KD9203 Firmware V2.2.37_221212 Release Note (2022-12-20)

Device Model	DS-KD9203-E6、 DS-KD9203-FE6、 DS-KD9203-TE6、 DS-KD9203-FTE6
Firmware Version	V2.2.37_221212
iVMS-4200 Version	Late version
Hik-Connect APP	Late version

Face Recognize Door Station Firmware V2.0.0_210120 Release Note (2021-02-01)

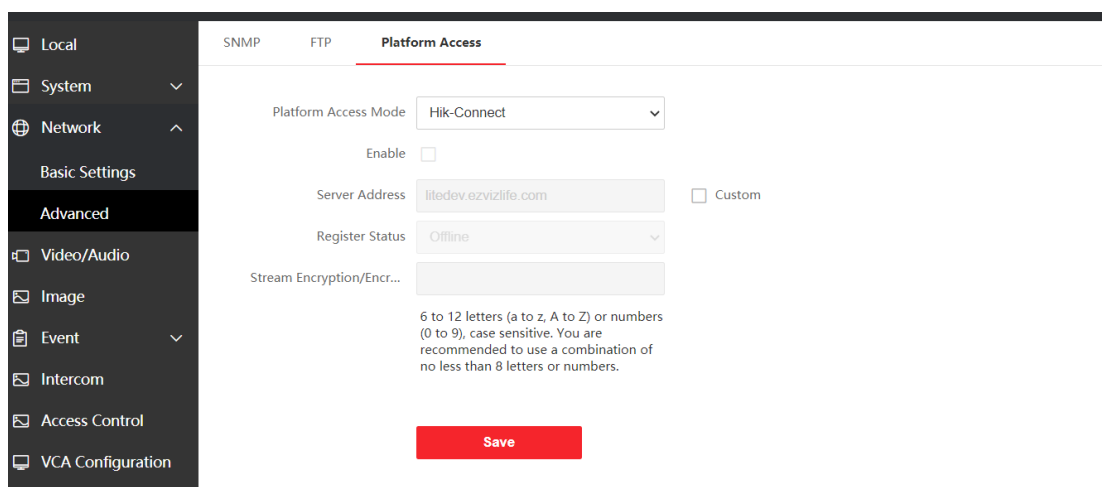
- 1、 When Door Station call Indoor Station by “Outer Door Station” mode (with protocol 2.0), there is no message record in Indoor Station.
- 2、 The device will be rebooted caused by switching Portuguese.

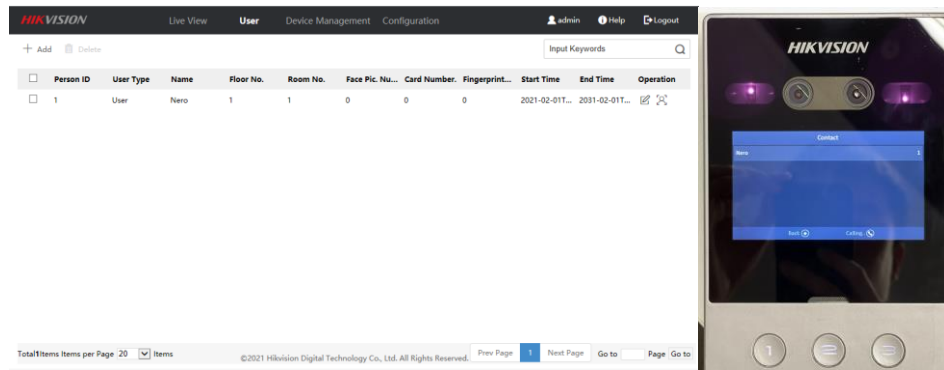
1. Support address book function

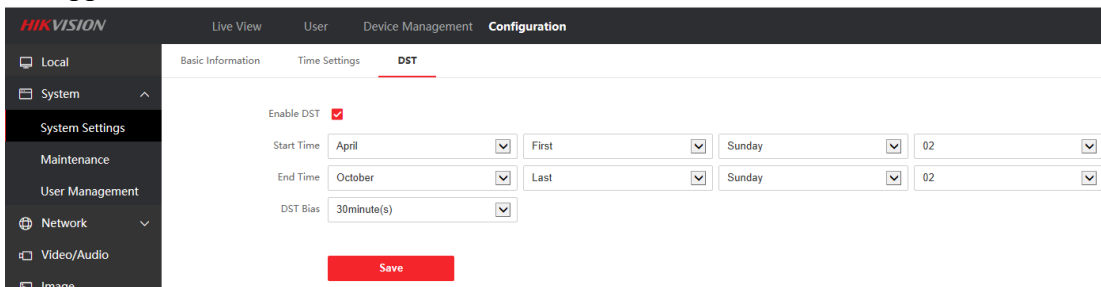
2. Support DST function

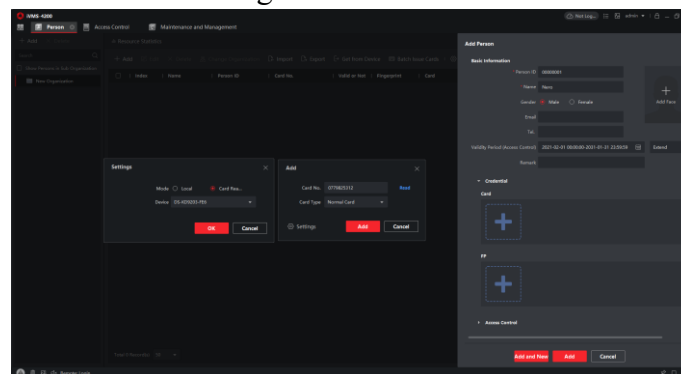
1. Fix the problem that iVMS-4200 cannot get the card number
